CITY OF ALBUQUERQUE PLANNING DEPARTMENT October 4, 2006 **DRB Comments**

PROJECT # 1005171

RE: Parcel D, Westland North/sketch

Sketch Plat Review and Comment for Grasslands

Site: Parcell D of Westland North

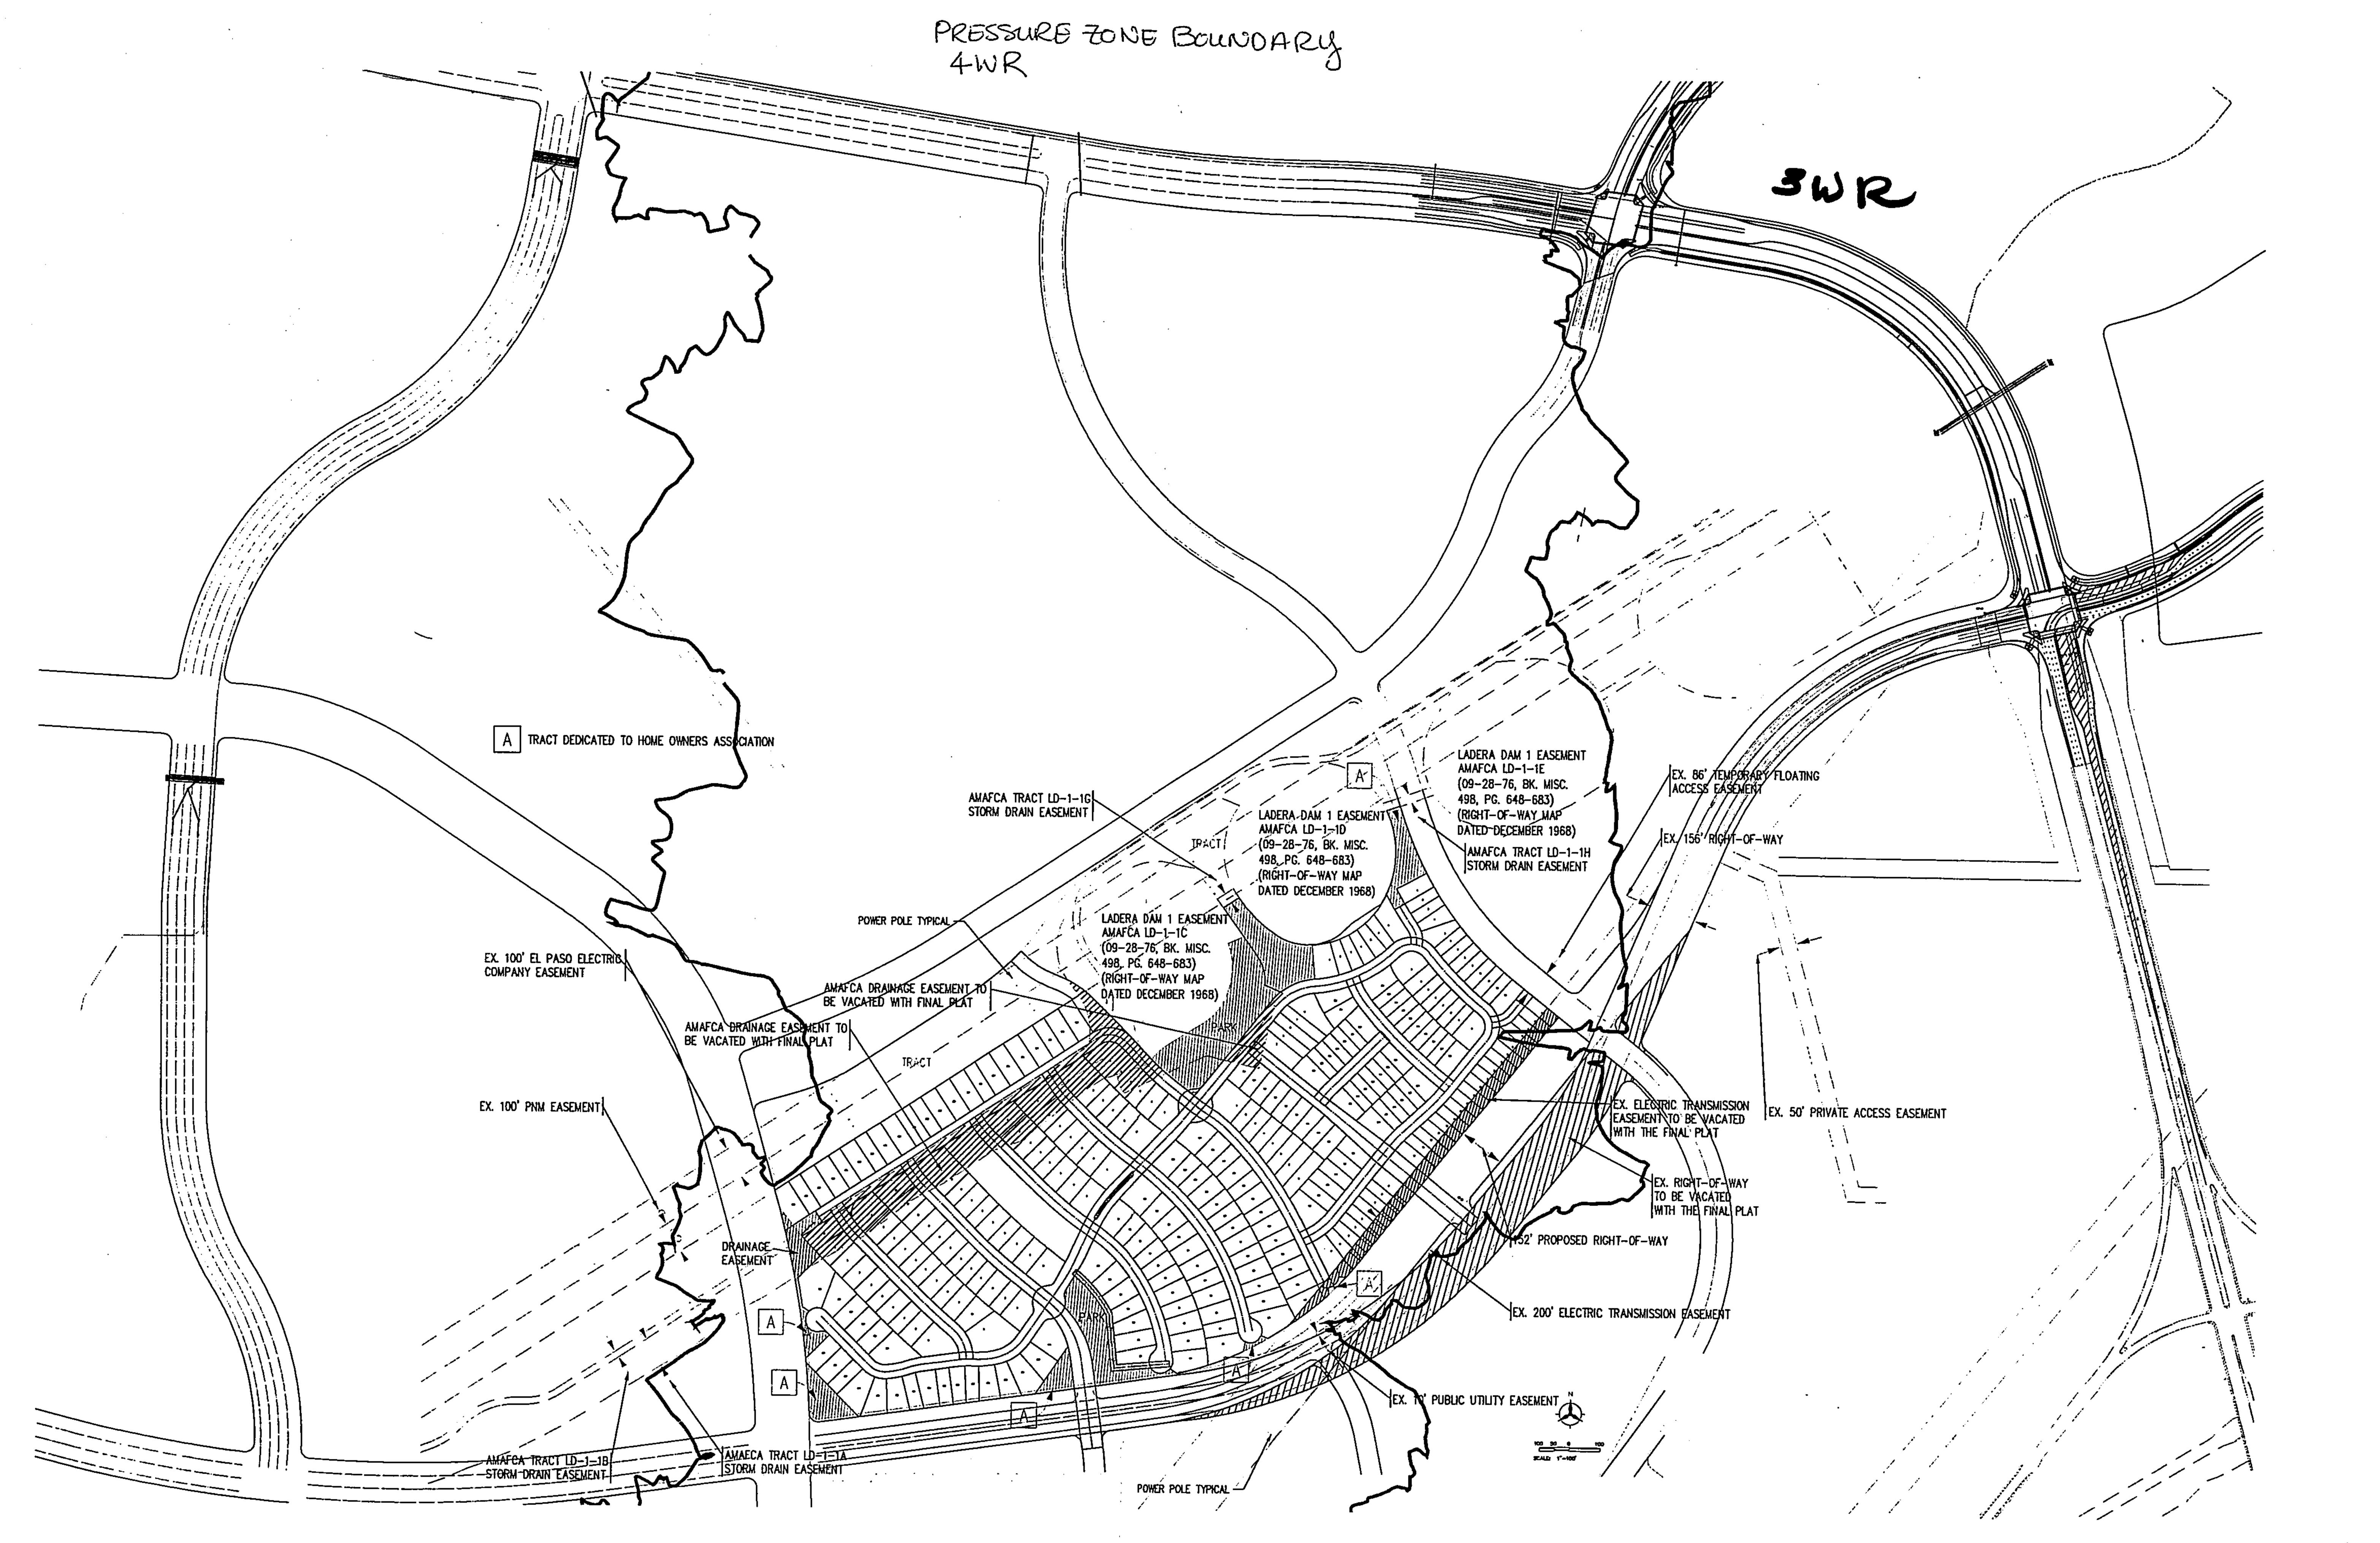
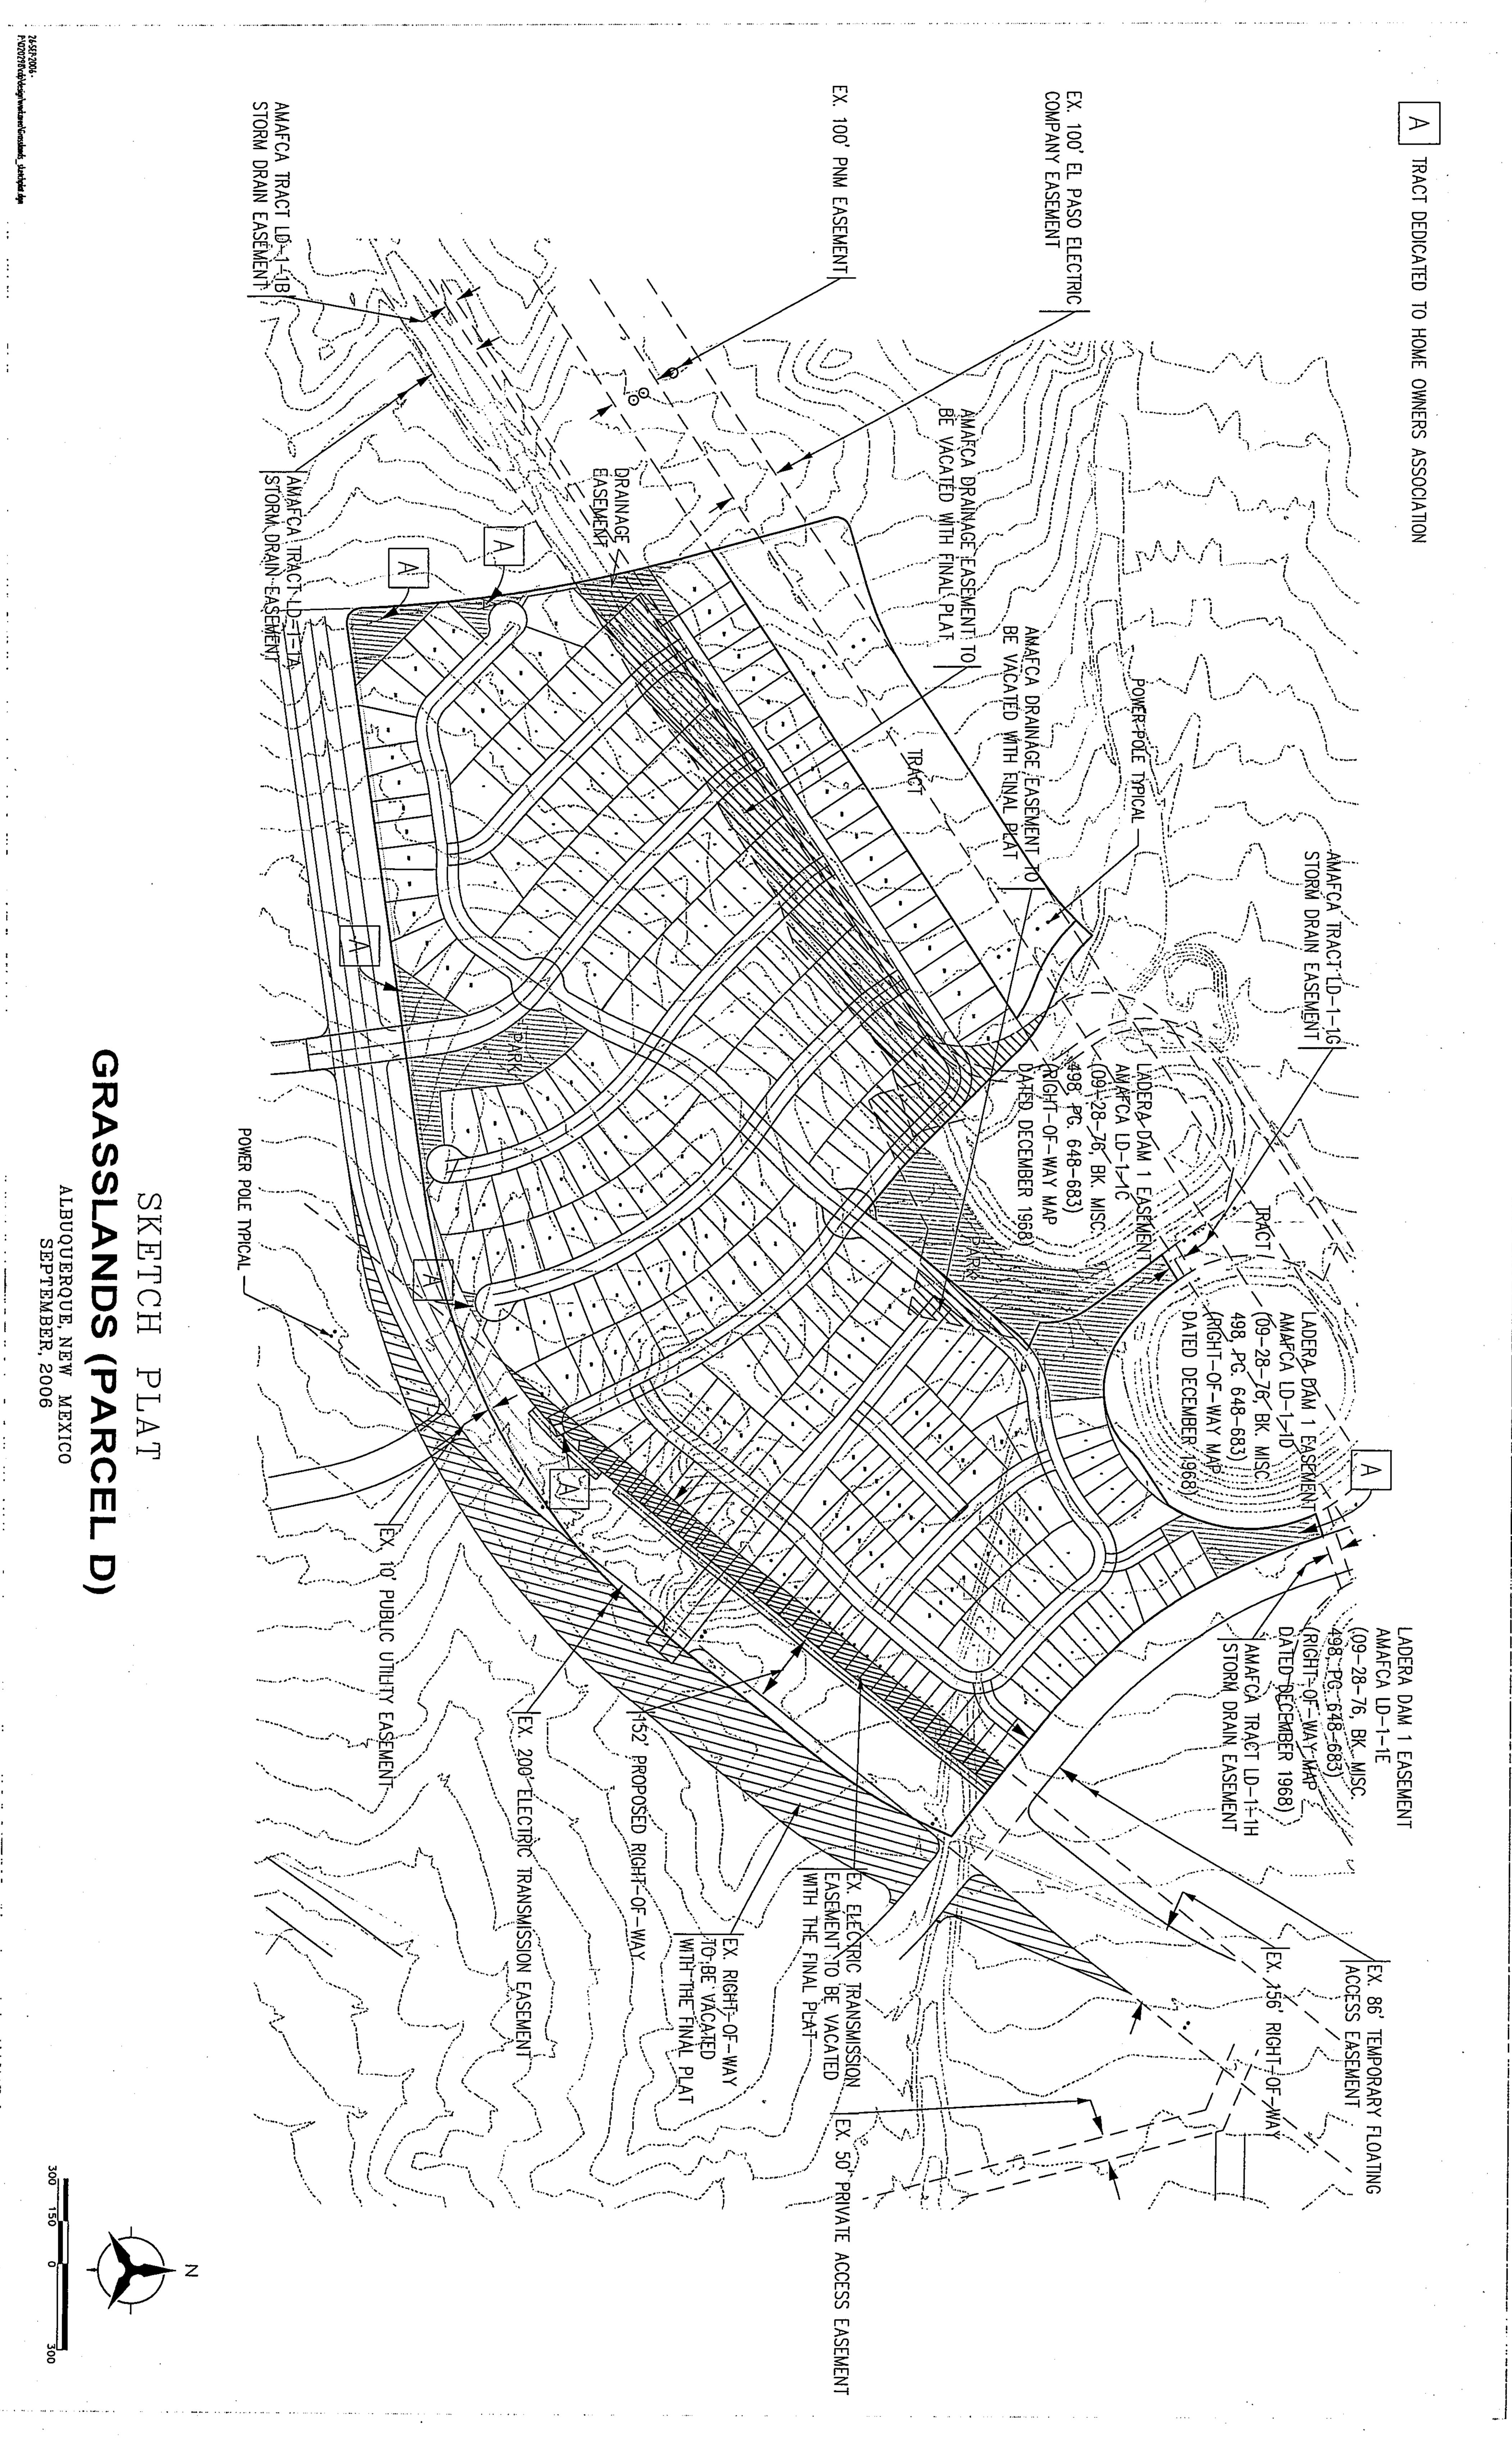
If this property lies within the Westland North Master Plan and Sector Plan Boundaries, be sure to follow those requirements.

An approved infrastructure list is required for Preliminary Plat approval.

An approved grading and drainage plan must be on file prior to Preliminary Plat approval.

AMAFCA concurrence is required.

- 1) Has the TIS been completed?
- 2) The City of Albuquerque will not accept public right-ofway encumbered with a PNM easement.
- 3) How does this subdivision fit with the Master Plan?
- 4) A traffic distribution map will be needed to determine street sections.
- 5) Standard infrastructure per the DPM is required.
- 6) Many of the block lengths exceed the DPM requirements.
- 7) Ensure that the cul-de-sacs meet DPM criteria.
- 8) Are there enough access points?
- 9) Why is Ladera being narrowed to 152'? Is Ladera paved to this subdivision? Will it connect to the West?
